Downtown Omaha Residence Inn  
APMA Project #09001  
27 June 2012

ADDENDUM #2

# Downtown Omaha Residence Inn by Marriott

sketch **M5.04a**

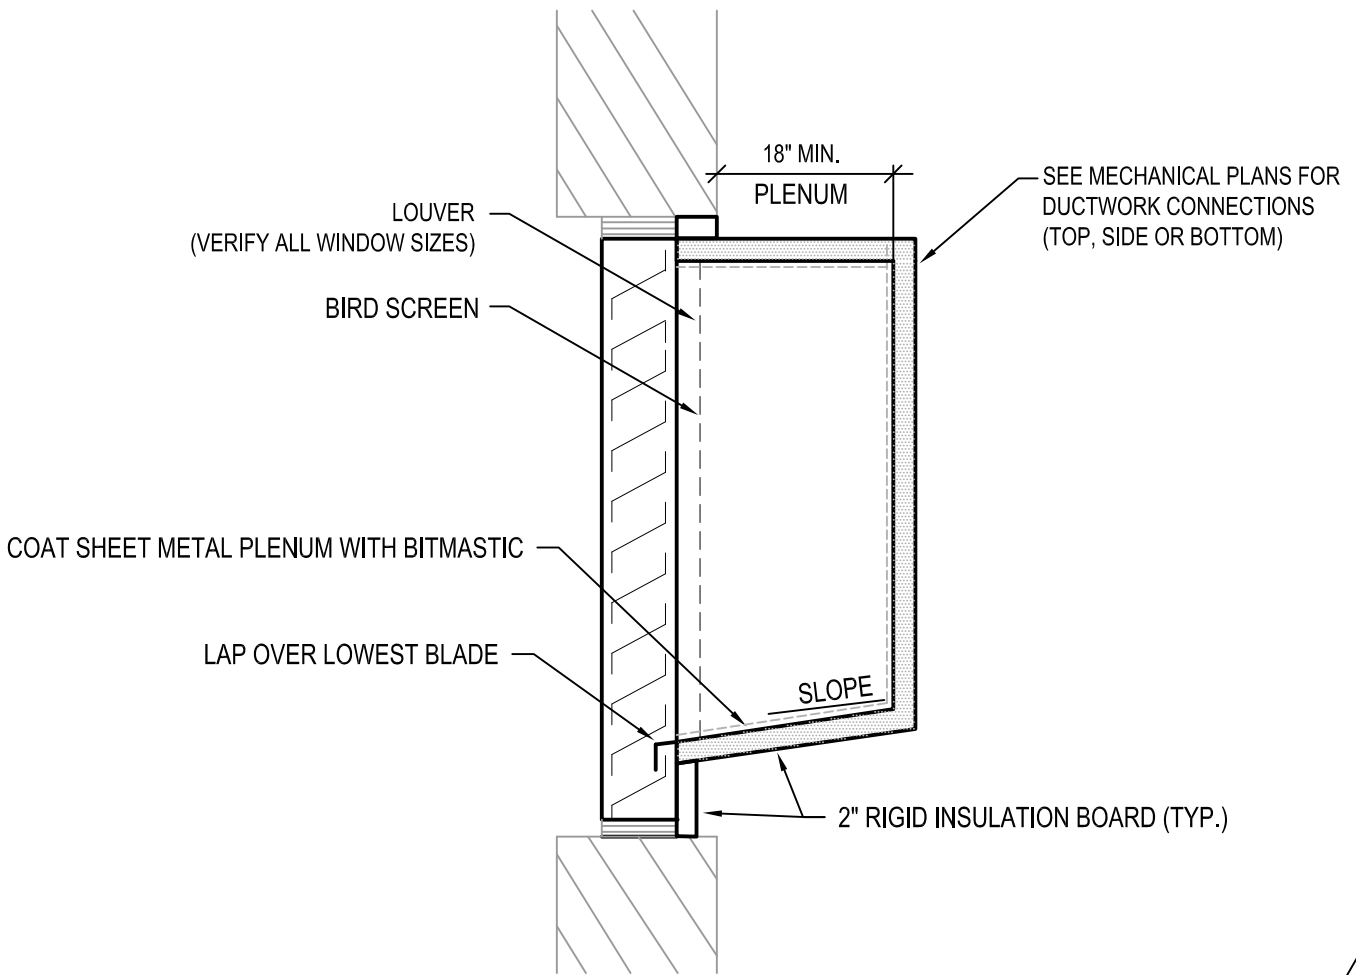
- a. See Sketch M5.04a
14. Sheet M6.01 MECHANICAL DETAILS
  - a. See Sketch M6.01a
15. Sheet M6.03 MECHANICAL DETAILS
  - a. See Sketch M6.03a
16. Sheet M6.04 MECHANICAL DETAILS

sketch **M7.01a**

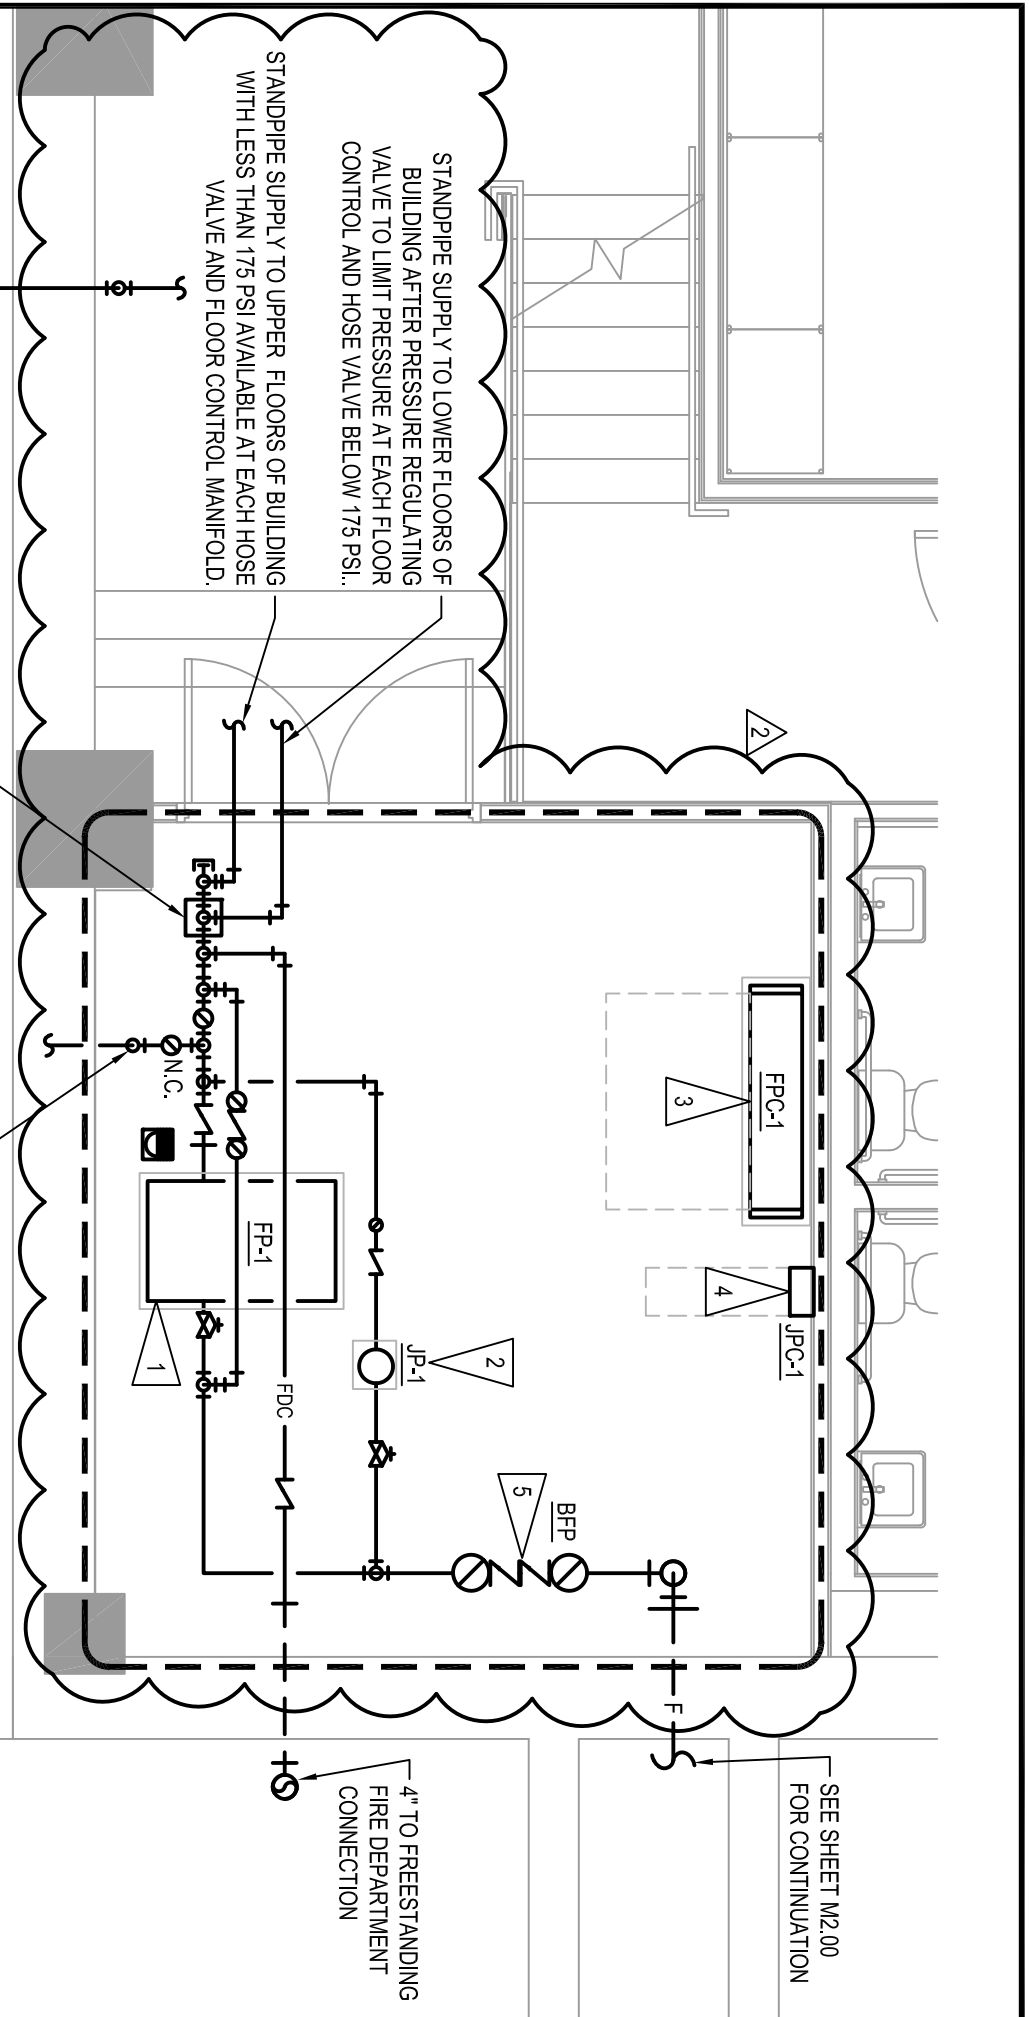
17. Sheet M7.01 MECHANICAL SCHEDULES
  - a. See Sketch M7.01a
18. Sheet FP1.00 FIRE PROTECTION PLAN
  - a. See Sketches FP1.00a, FP100b, FP100c and FP100d

E1.07a

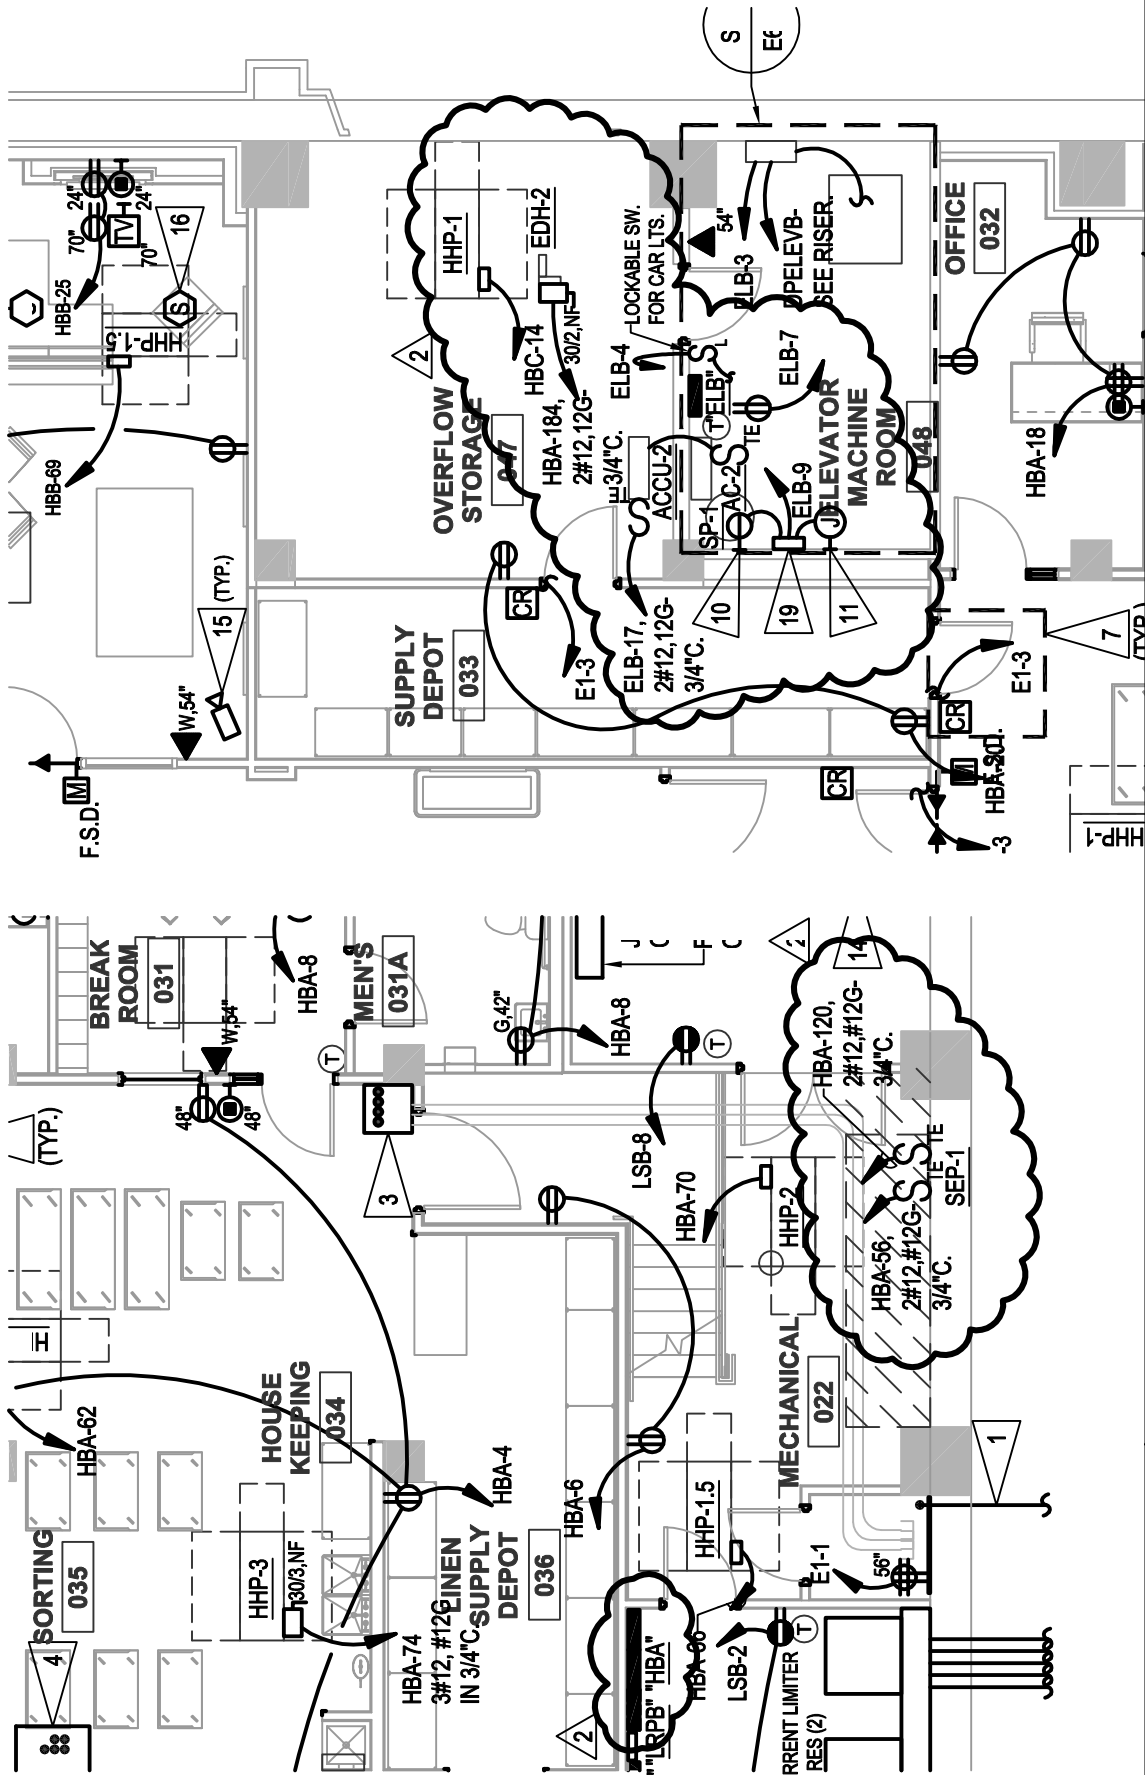
4. SHEET E1.07, MECH LEVEL PLAN – ELECTRICAL.
  - a. Provide electrical connections to sump pump controllers per attached sketch sheet E1.07a.
  - b. Relocate electrical connections to motorized dampers per attached sketch sheet E1.07a.
